Our Ref: 24003 DA RFI Response 12 Murphy Street

**RFI CIVIL RESPONSE SUBMISSION
MCU - DWELLING HOUSES MCUC 2023_5563
12 MURPHY STREET, PORT DOUGLAS (L113 PTD2094)**

We refer to Douglas Shire Council's (Council) Information Request (IR) dated 1 February 2024.

CH 40

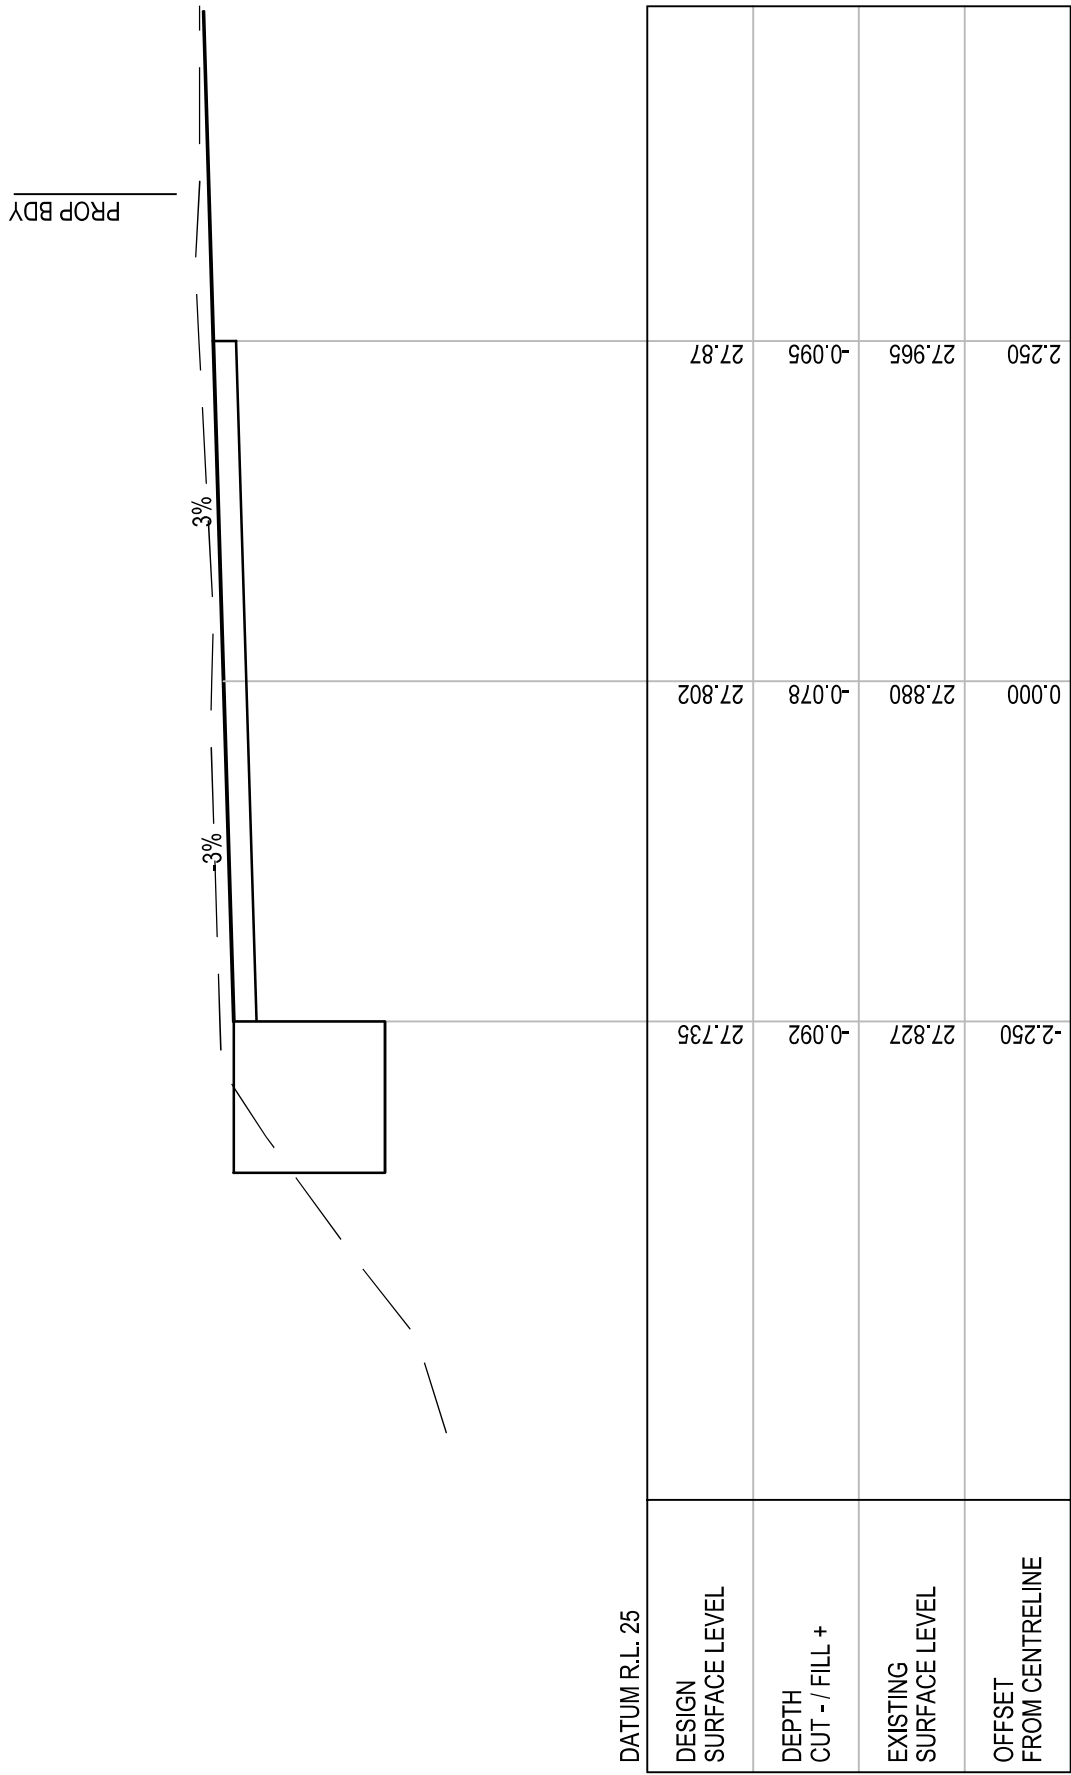
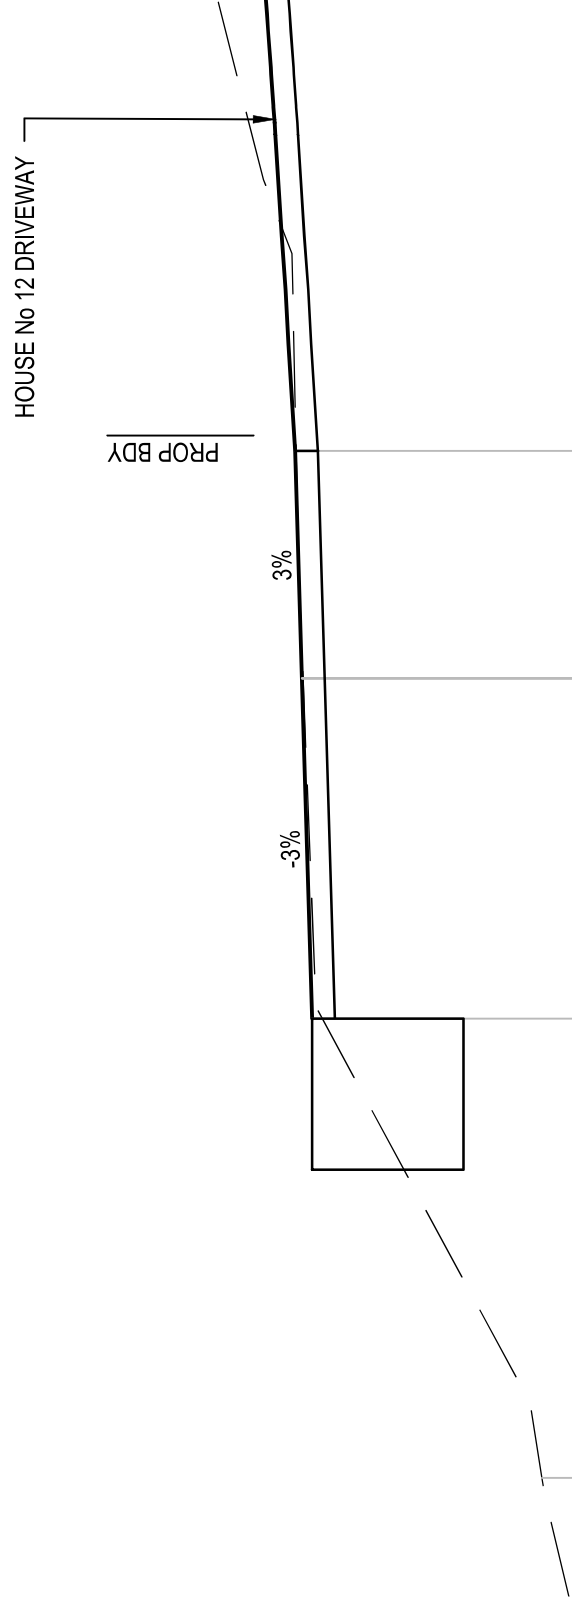
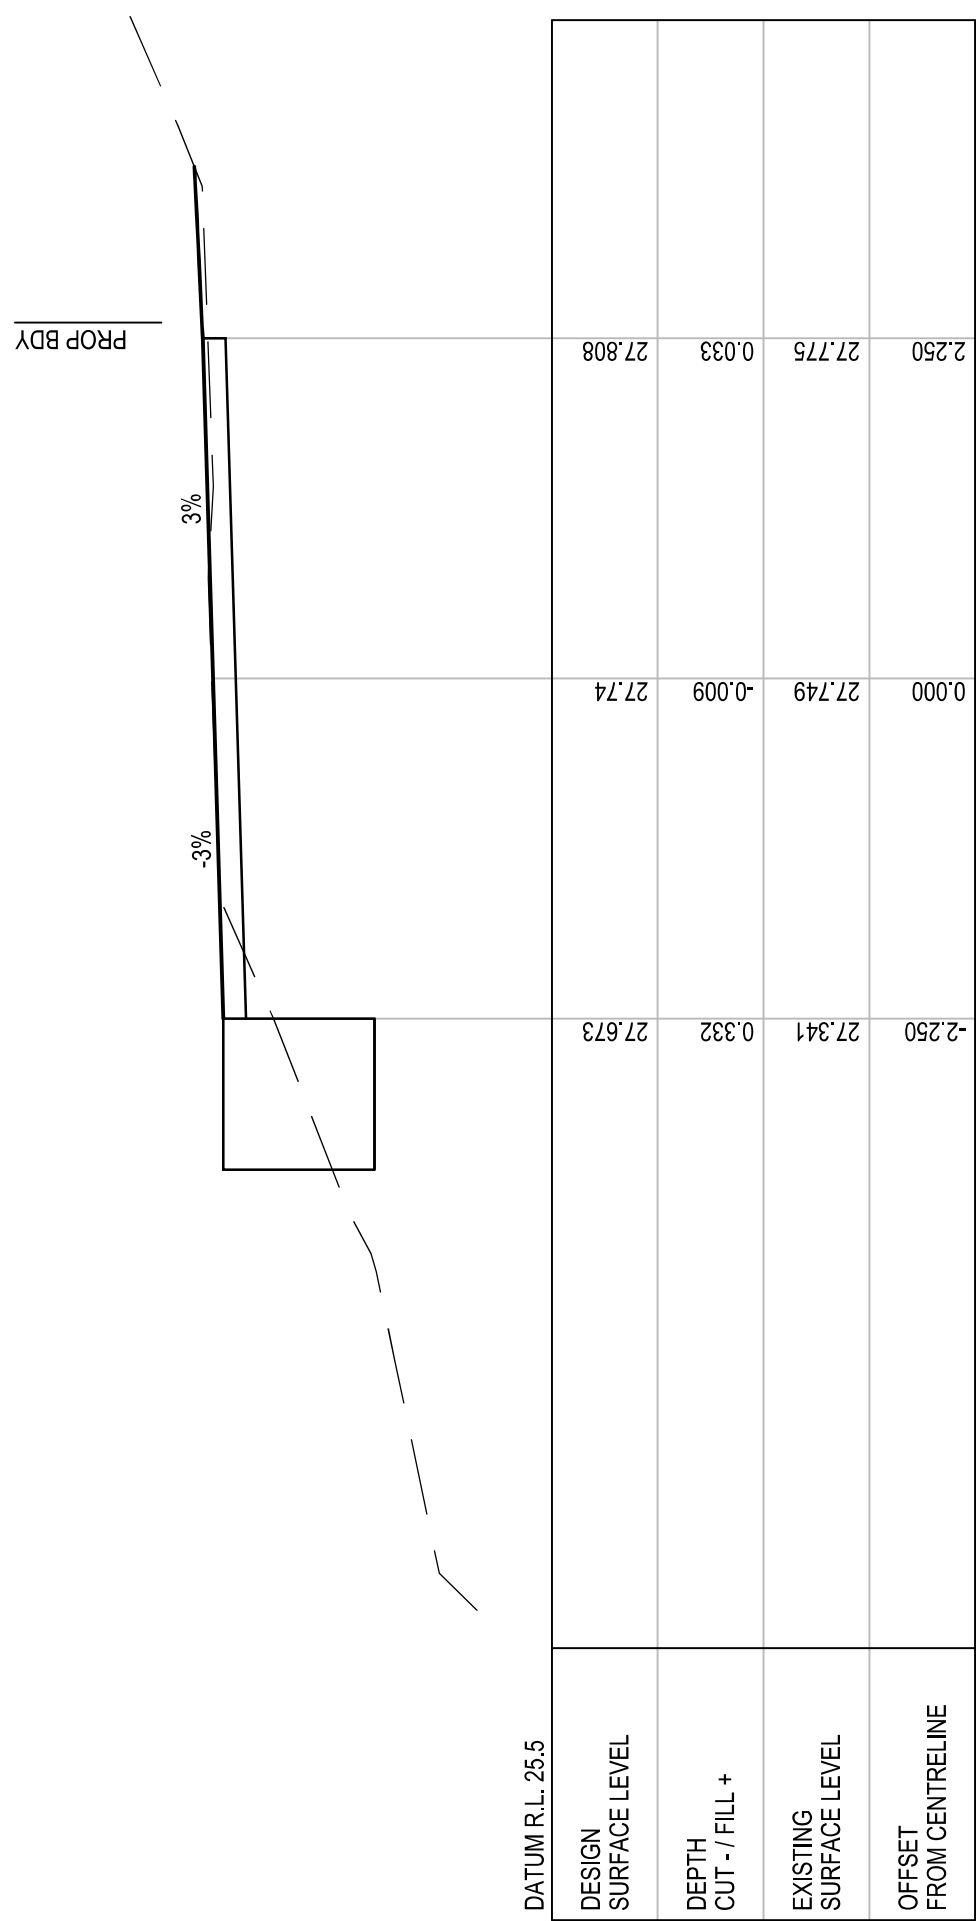
6. *Provide further information in the form of longitudinal and cross sections indicating the cut and fill required to construct the shared access in Murphy Street, and the internal driveway.*

Refer sketches provided in **Appendix B**.
